SERVICE BULLETIN

M-1116

ENGINE SPROCKET NUT

Figure 1. Engine Sprocket Nut

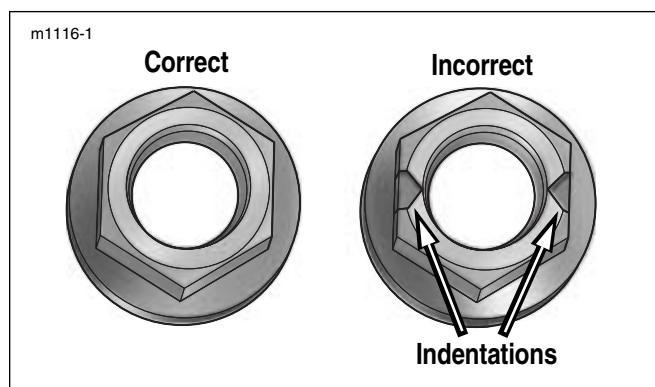
The purpose of this bulletin is to notify dealers that some Sportster motorcycles were produced with incorrectly manufactured engine sprocket nuts. The incorrectly manufactured nut has an interference fit which may result in a false torque reading. This can cause the nut to lose clamp load on the engine sprocket, allowing the sprocket and alternator rotor to loosen and create noise.

See [Figure 1](#). A good, serviceable sprocket nut is shown on the left side of the figure. An incorrectly manufactured nut is shown on the right, identified by two arrow-shaped indentations on the face of the nut.

In the event that a customer complains of an unusual noise, start the motorcycle and inspect for a noise in the primary housing. If any unusual noise is heard in the primary housing, shut the motorcycle off, remove the primary cover and inspect the engine sprocket nut.

If an affected motorcycle has been brought in for repair and the primary cover is removed, inspect the engine sprocket nut. Replace if it is determined to be an incorrectly manufactured nut.
